Scope Amendment

Amendment description
<p>Pipe work</p> <p>IM-FP 0908(95)362 McCook PCN 05HP I90 EBL - Fm 2 W of the Salem Interchange to 2 W of Humboldt; I90 Strs - 0.6 W of the US81 Interchange Over W Fork of the Vermillion River; I90 Strs - 2 E of the US81 Interchange Over 443 Ave; I90 Str - 2.1 W of the Minnehaha Co Line Over the E Fork of the Vermillion River; I90 Str - 1 W of the Minnehaha Co Line Over 453 Ave Remove & Replace PCC, Pipe Work, Replace Str & Approach Grading, Deck Overlay, Approach Slabs, Polymer Chip Seal</p> <p>IM 0908(97)362 McCook PCN 05HQ I90 WBL - Fm 2 W of the Salem Interchange to 2 W of Humboldt; I90 Str - 0.6 W of the US81 Interchange Over the W Fork of the Vermillion River; I90 Str - 2 E of the US81 Interchange Over 443 Ave Remove & Replace PCC, Pipe Work, Replace Str Bridge, Approach Grading, Deck Overlay, Approach Slabs, Polymer Chip Seal</p>
Amendment Summary
<p>Pipe replacements were scheduled at the following locations with PCN 041F:</p> <p>Sta. 476+00 (MRM 362.09 +0.125) EB & WB Lanes - In place 24 CMP & Flared Ends to be replace with 24 RCP & Sloped Ends.</p> <p>Site 2 on 041F.</p> <p>Sta. a 278+00 (MRM 370.04 +0.225) EB Lanes - In Place 18 CMP

I-90 EASTBOUND - SALEM REST AREA - TRUCK LAYOUT

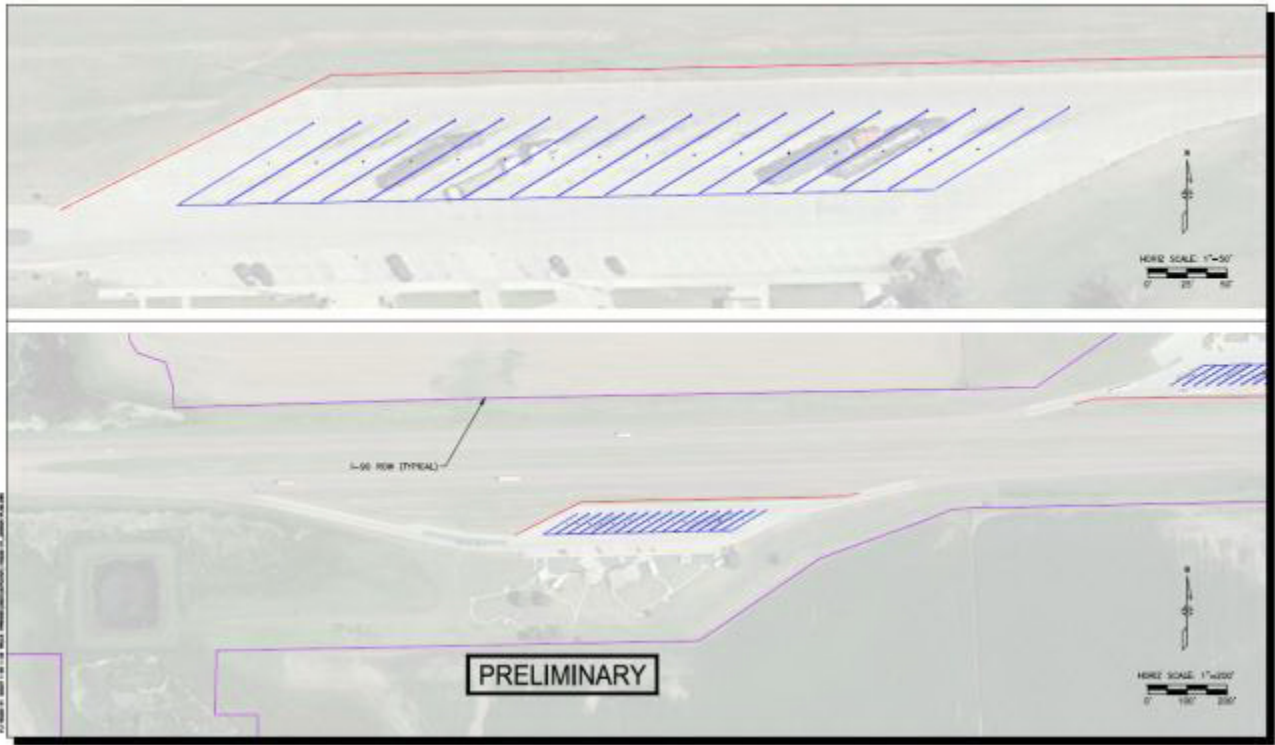
[It was determined that the Salem WB rest area would require 10 additional parking spot. The parking lot will be expanded to the east centering the truck parking area on the rest area building to minimize the walking distances from the furthest parking spaces to the building. The expansion on the east end of the rest area requires a new alignment for the I90 exit ramp \(entering the rest area\) to meet the deceleration length requirements. The layout from the study can be seen in the Appendix tab.](#)
